December 2, 2003

L-2003-276  
10 CFR 50.90

RE: St. Lucie Unit 2  
Docket No. 50-389  
Proposed License Amendment  
WCAP-9272 Reload Methodology and  
Implementing 30% Steam Generator Tube Plugging Limit

FIGURE 2.1-1: REACTOR CORE THERMAL MARGIN SAFETY LIMIT LINES  
FOUR REACTOR COOLANT PUMPS OPERATING

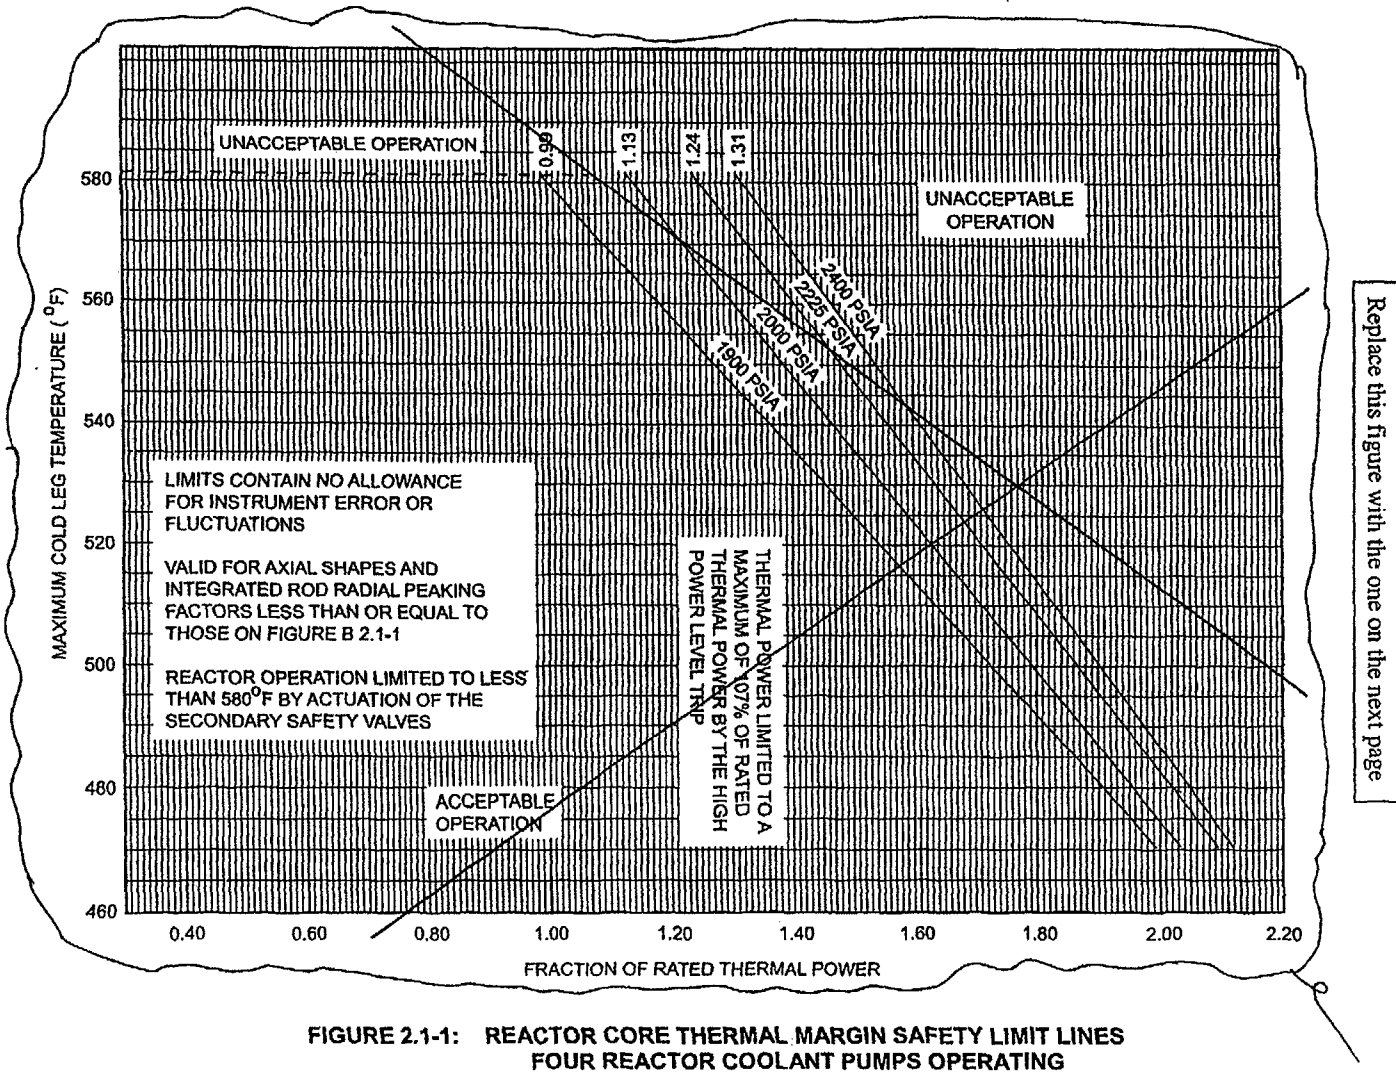
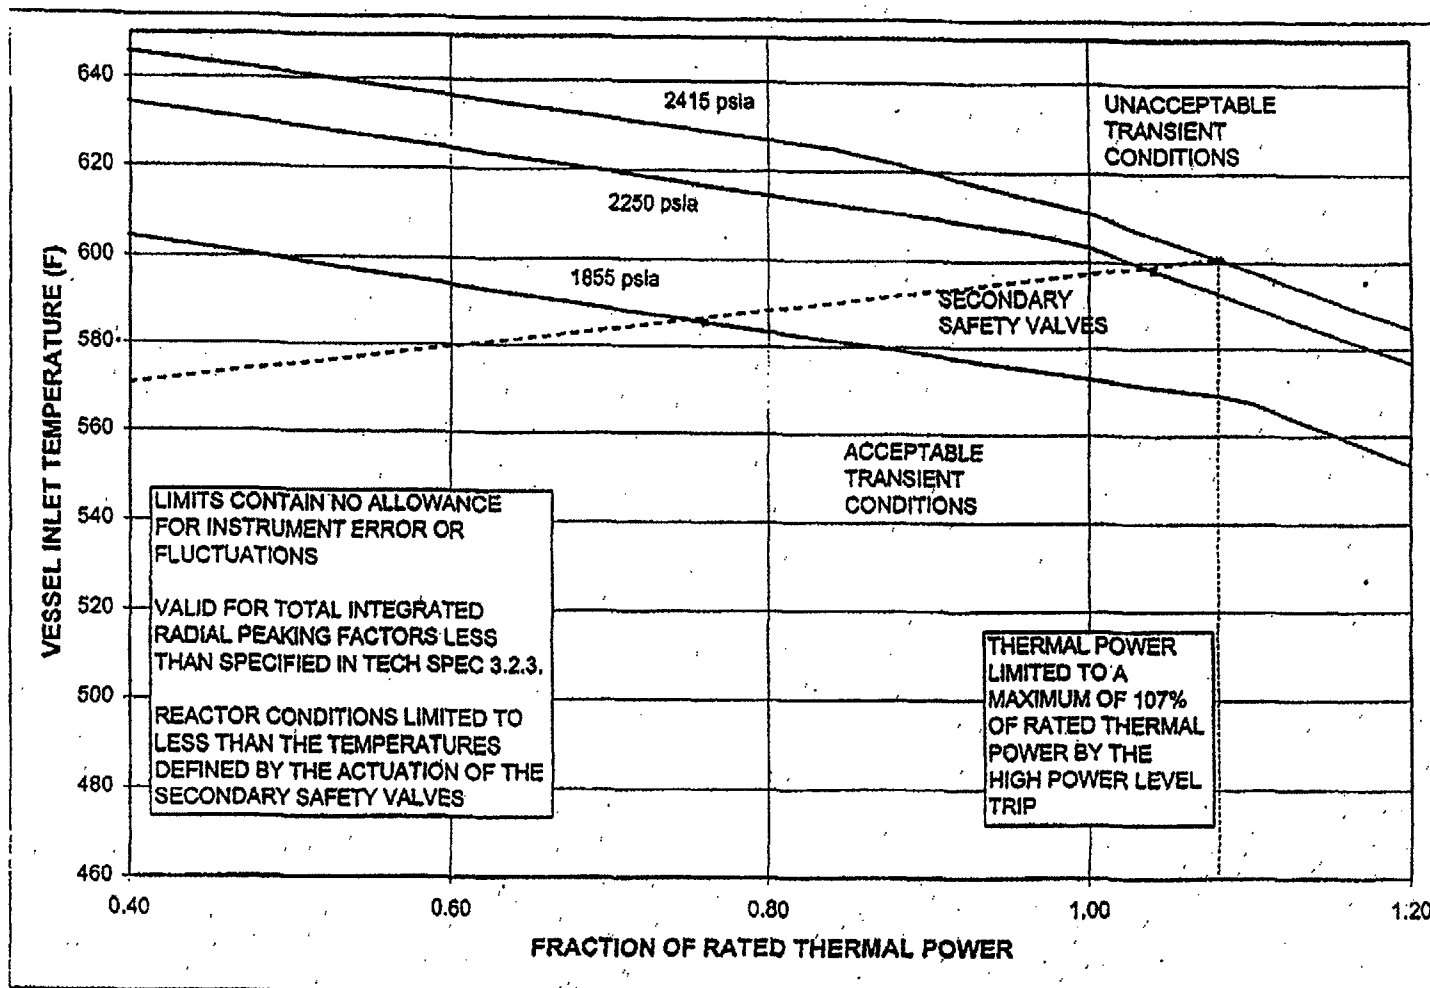
- 2.2 TS Page 2-3, TS Safety Limit 2.1.1: (Reactor Core), Figure 2.1-1 Thermal Margin Safety Limit Lines and TS Bases Figure B2.1-1

TS Figure 2.1-1 is revised to reflect the reduction in RCS flow from 355,000 gpm to 335,000 gpm and the changes to the methodology. The revised TS basis Figure B2.1-1 reflects the axial shapes used in the generation of the DNB lines on TS Figure 2.1-1.

Figure A-1 Proposed AXIAL SHAPE INDEX Limits for Linear Heat Rate when Using Excore Detector Monitoring System (COLR Figure 3.2.2)

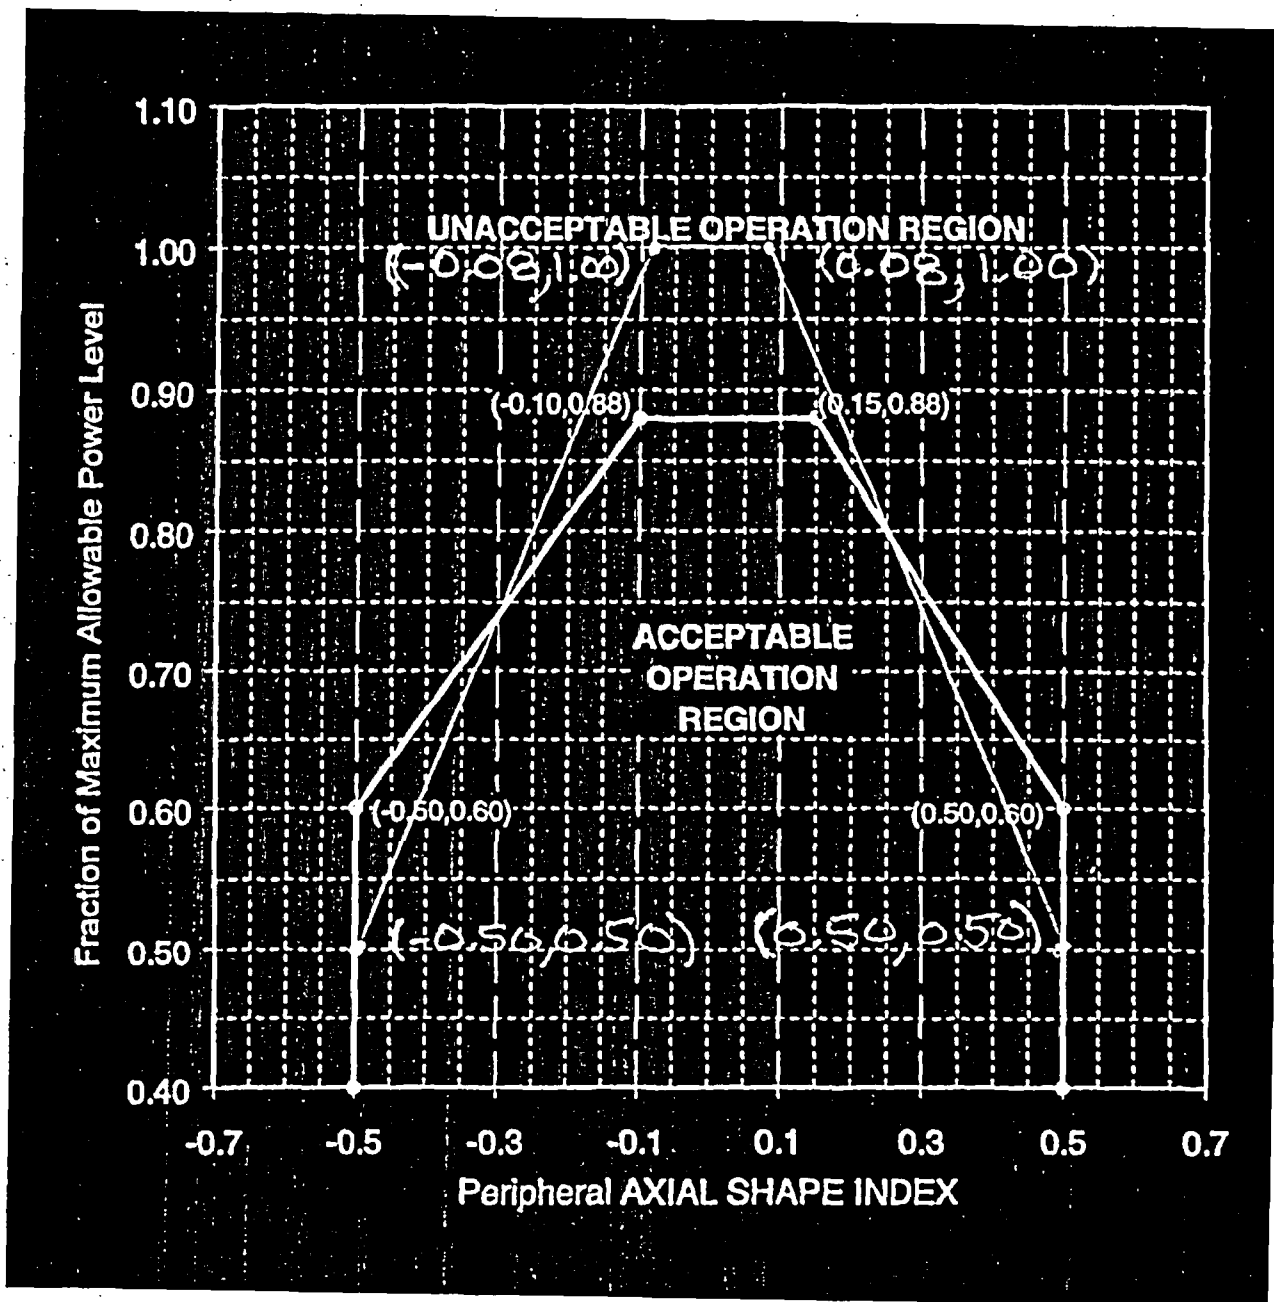
Note that future activities may result in relaxation of 12.5 kw/ft peak linear heat rate limit. Recalculation of the RAOC cases under a relaxed peak linear heat rate assumption could then serve as the basis for relaxation of the ASI limits for linear heat rate when using the EDMS, which would be implemented through the COLR on a cycle-specific basis.
